DD116 Lot 972 Vehicle Park

DRAINAGE PROPOSAL

Drainage Proposal for Temporary Office and Private Vehicle Park

Comments of the CE/MN of DSD:

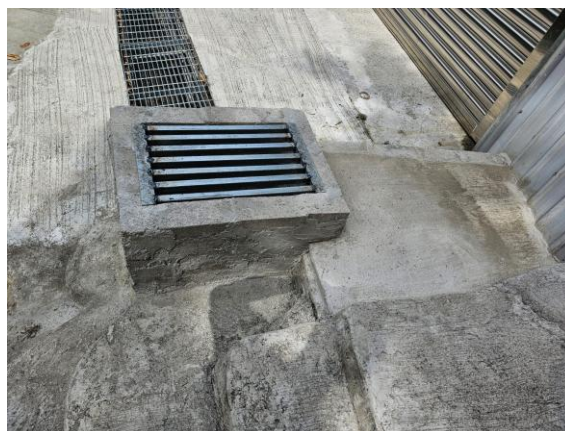
- v) According to Photo 2, the existing 300mm u-channel was covered with timber, which is not desirable to intercept the overland flow from the adjacent lands. Please review.

- v) The existing 300mm u-channel as shown on Photo 2 was covered by timber board as to temporarily protect the channel from falling dirt and mud alongside the verge which belongs to Lands Department purview.
The owner has contacted the Yuen Long District of Lands Department to cleanse the u-channel and provide the grating cover permanently.
At the moment the owner conducts the cleansing regularly by himself as to maintain the good of the u-channel.

The above photos were taken early May 2025 showing the said timber board was removed from the 300mm u-channel and the u-channel is now adequately in service.

Drawing No. 04 Direction of Surface Run-Off

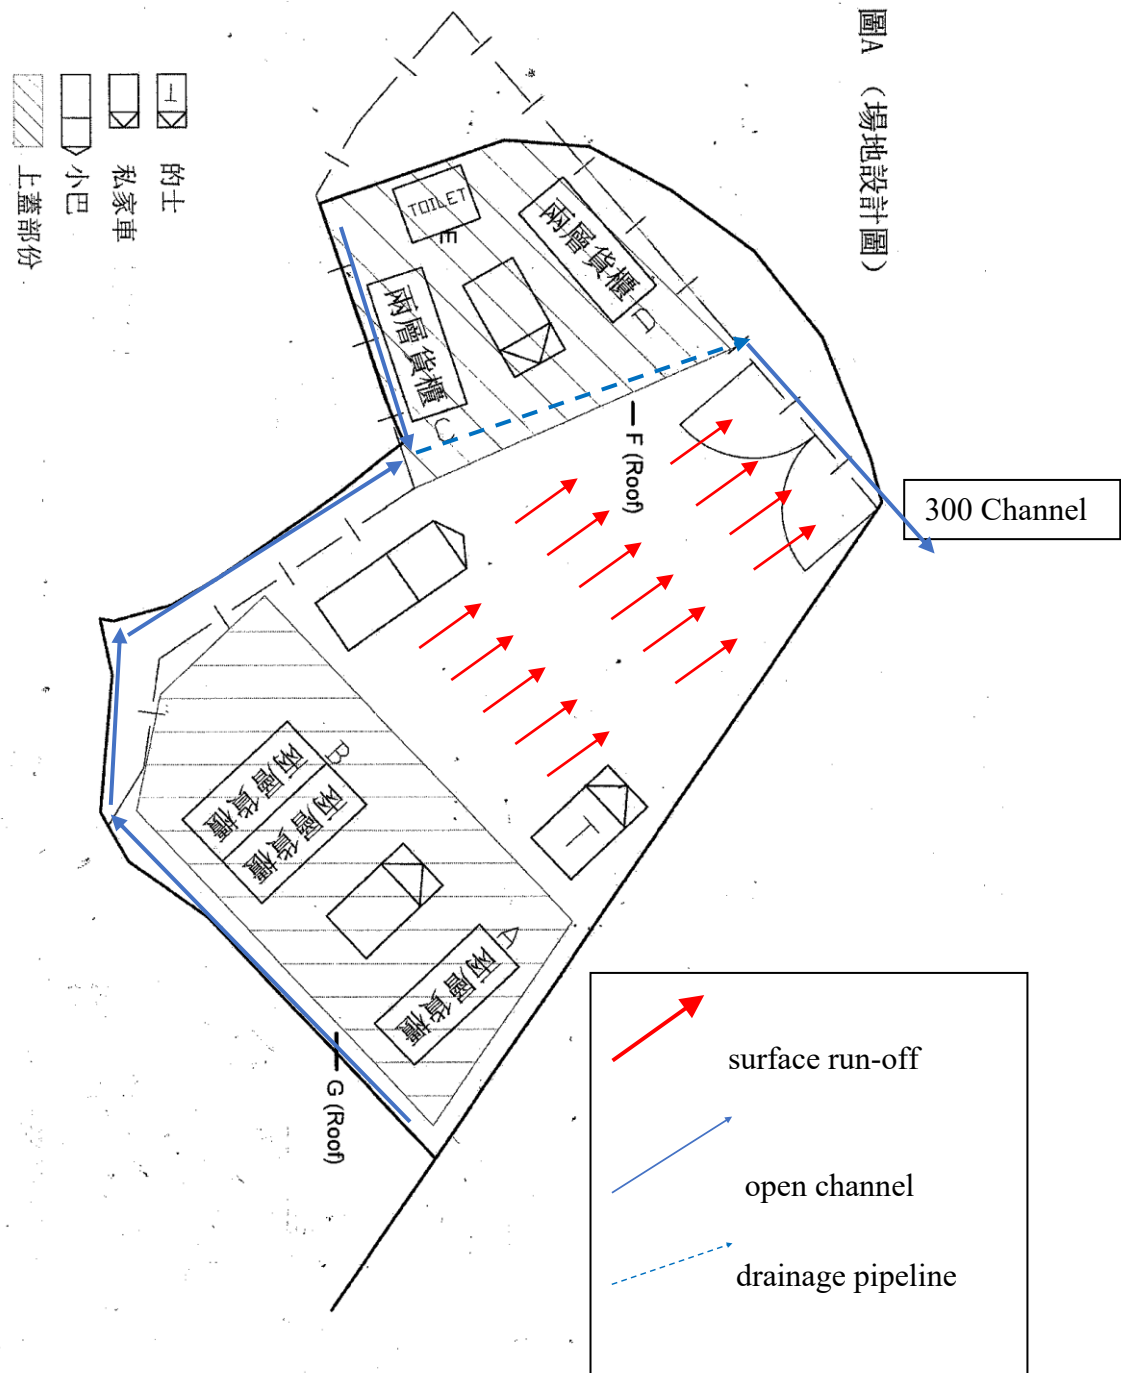
- iii) The cover levels and invert levels of the proposed u-channels, catchpits/sand traps should be shown on the drainage plan.
- iv) Besides, the drainage plan should be clearly indicated the full alignment of the discharge path from the application site all the way down to the ultimate discharge point (e.g. A well-established stream course/public drainage system). Peripheral surface channels shall be provided along the site boundary to collect the surface runoff accrued on the application site and to intercept the overland flow from the adjacent lands.

The surface run-off without obstruction from **Point B** onto **Points G, B and L** before get into Manhole named **Point M** then fully discharge onto the nullah (the surface run-off is shown on Drawing No. 4 in red arrows).

The flow direction of surface runoff is shown on **Drawing No.04** that the existing concrete pavement profile provides a smooth water runoff into the existing U-channel and then the catchpit. Therefore, the pavement surface has to be well maintained and no broken or damages to be occurred during the rainy season.

Drawing No. 06 The Cross Sections with Drainage Table (NTS)

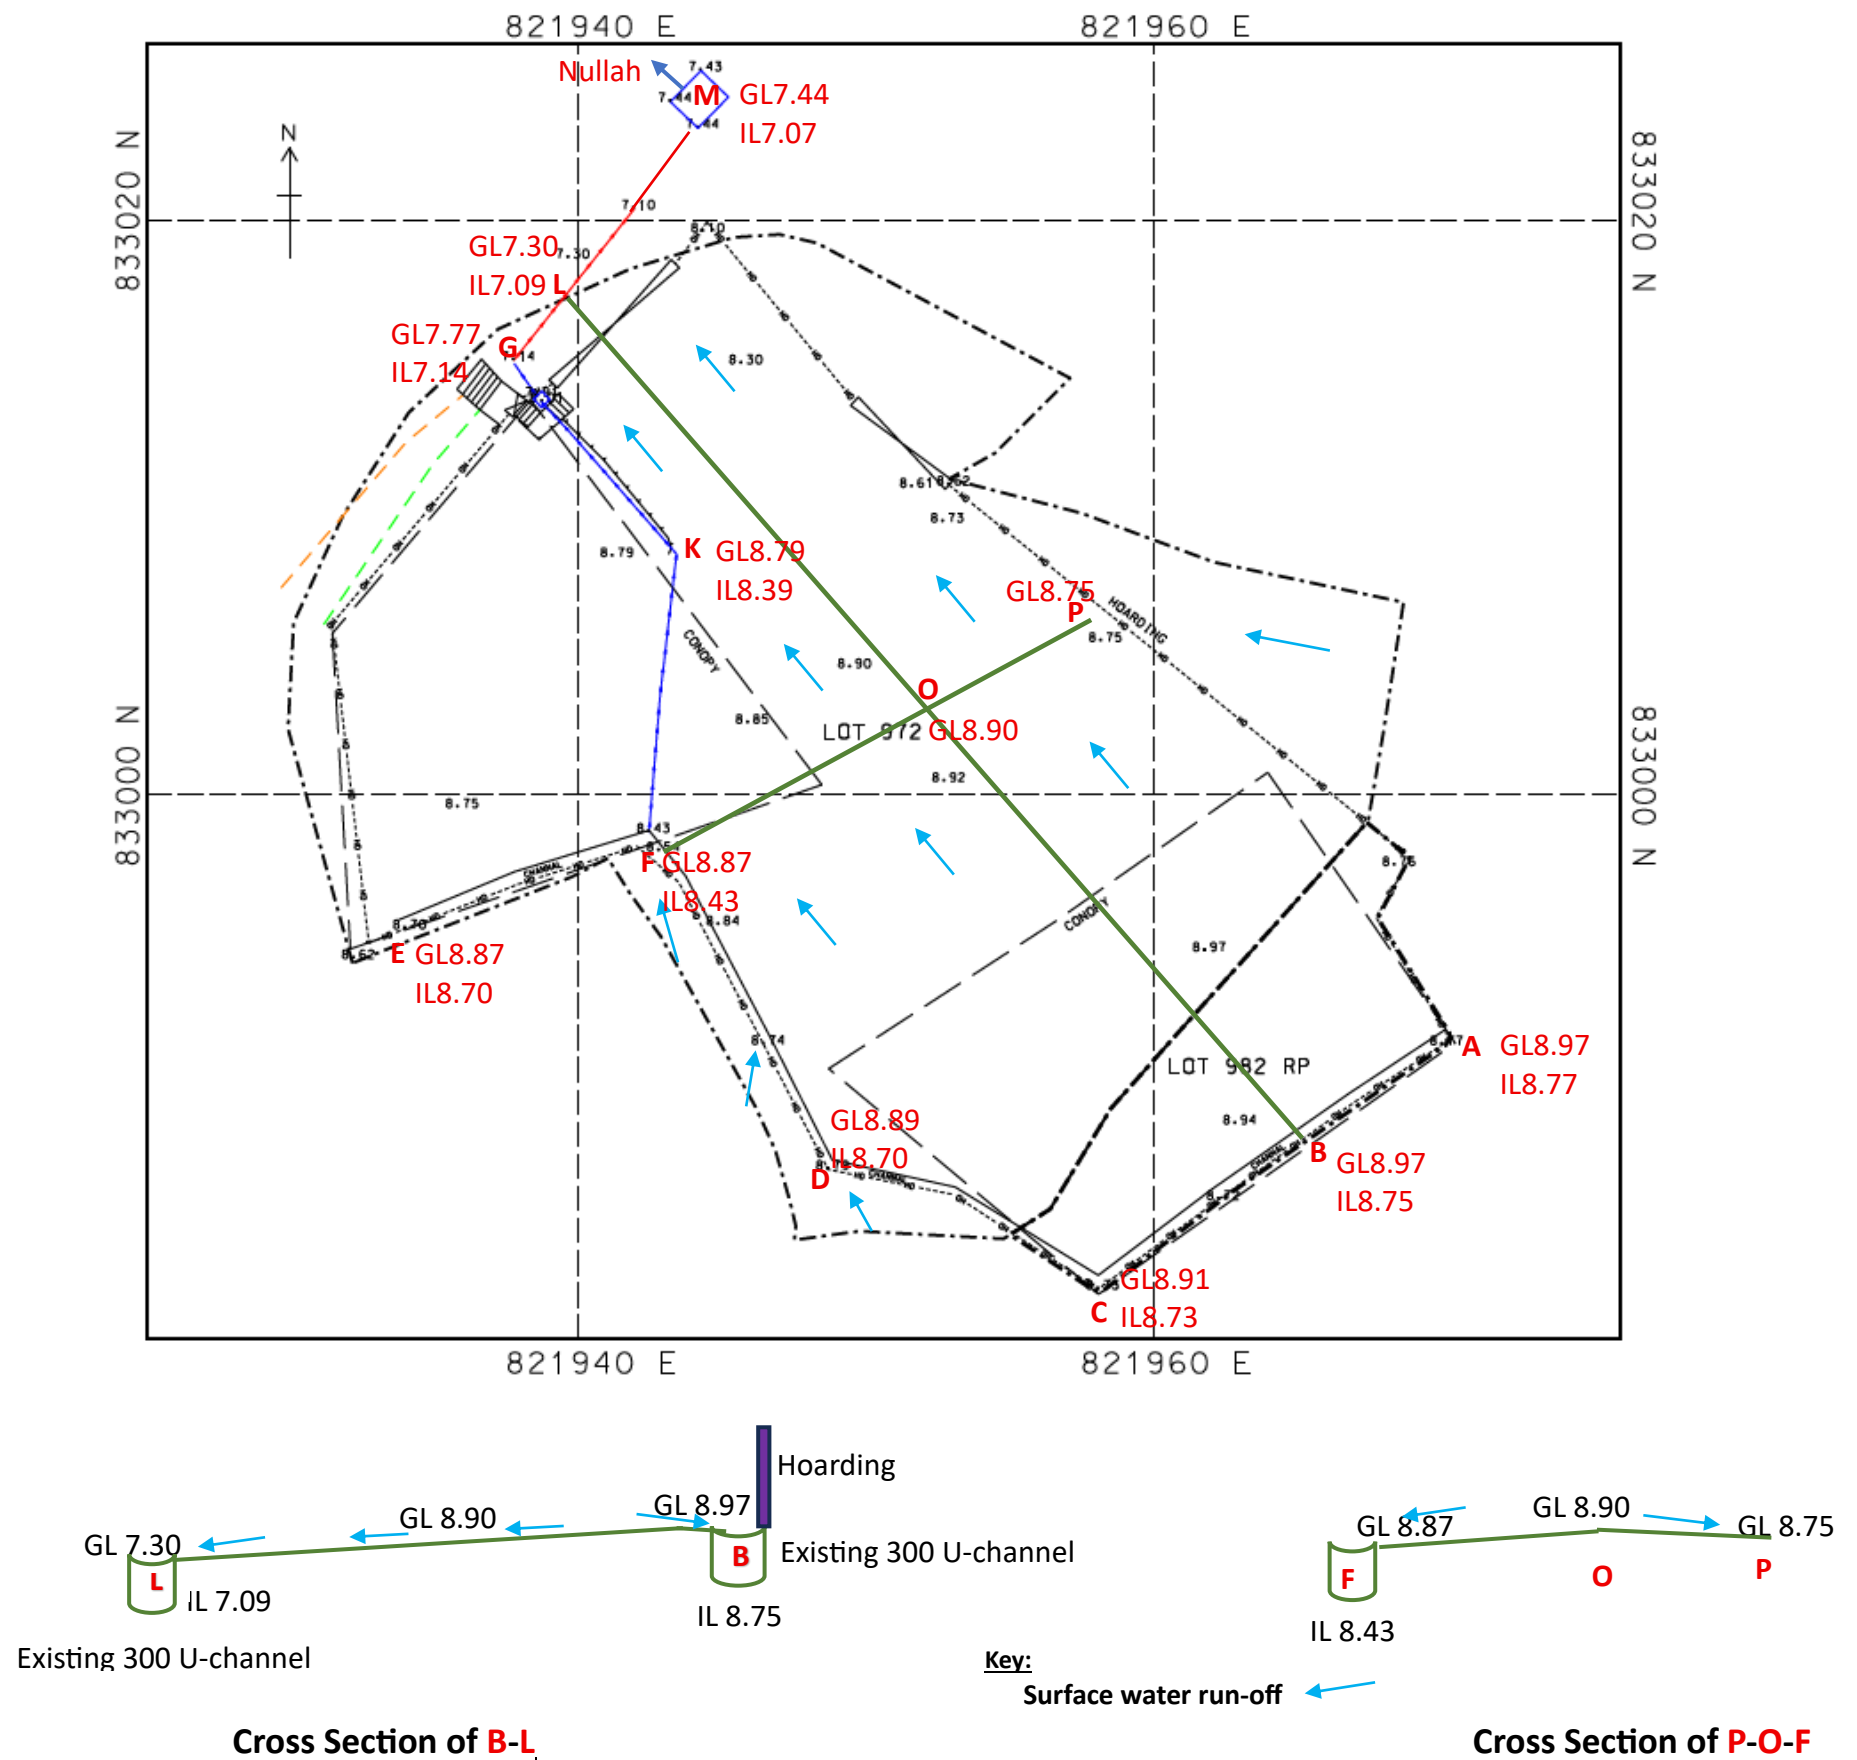
- i) Please make reference to the latest Technical Note No.1 issued by DSD for more details in preparing the drainage proposal.
- ii) Please provide a drainage plan showing all the existing and proposed drainage system on the drainage plan for comments. The gradients and the sizes of the proposed/existing drainage facilities should be shown on the drainage plan. Please also provide site photos to demonstrate the presence and condition of all existing drainage facilities for review.

ii) Please refer to **Drawing No. 6** of the overall Drainage Plan.
The gradients and sizes of the existing drainage facilities are also shown on the drainage plan; the existing gradient is 1:24 approximately towards the existing nullah.
Relevant site photos to demonstrate the presence condition of existing drainage system are listed herewith:

iii) The cover levels and invert levels of the existing u-channels and modified catchpit are as shown on the drainage plan on **Drawing No.s 6 and 7**.

iv) **Drawing No. 6**, the Drainage Plan shows the full alignment with Invert Levels and existing Ground Levels from **points A to B, C, D, F (and from E to F), K, G, L, M** then to the final discharge point of the nullah.

ix) The cross-sectional details of the existing 300mm u-channel and the catchpit are shown on **Drawing No.s 6 and 7** respectively for reference.

Drawing No. 7 Modification of Non-standard Catchpit at Point G

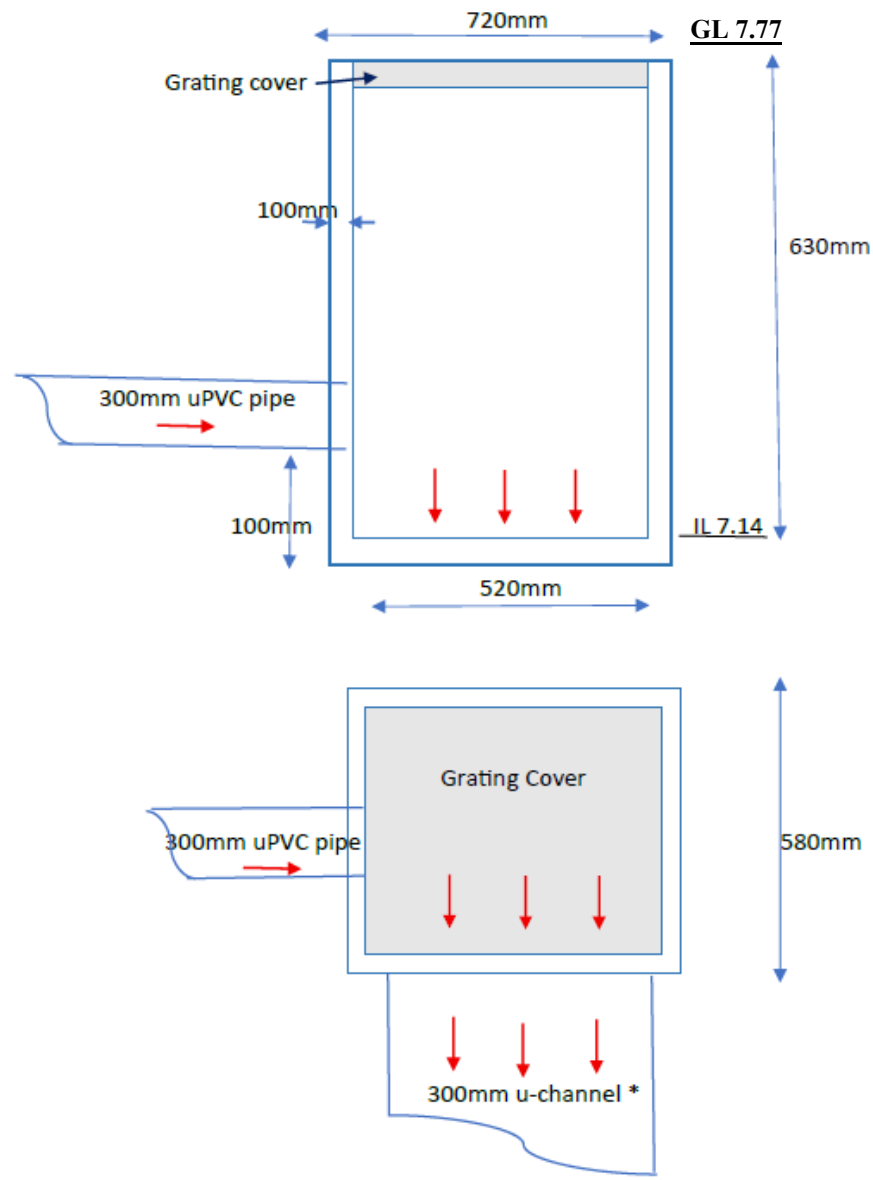
- vii) According to Photo E, it is not a typical sand trap or provision alike. Please be reminded that sand trap or provision alike should be provided inside the application site before the collected runoff is discharged to the public drainage facilities. Please make reference to DSD's standard drawing (DS 1025B) for the provision of sand trap for your information.

- ix) Standard details should be provided to indicate the sectional details of the proposed u-channel and the catchpit/sand trap.
- x) The development should neither obstruct overland flow and nor adversely affect existing natural streams, village drains, ditches and the adjacent areas, etc.

- vi) Please note that no site formation was carried out in the history, therefore no construction of wall / structural hoarding is under this application at all.
So, it is confirmed that there is no site formation/levelling works to be carried out under this application.
- vii) Yes, Photo E indicated a nonstandard catchpit which was constructed by previous land owner.
Instruction was given to the new owner to modify the catchpit early May 2025.
Below please find the modification of the said catchpit:

The nonstandard catchpit was modified as on 28 May 2025 as shown on **Drawing No. 7**
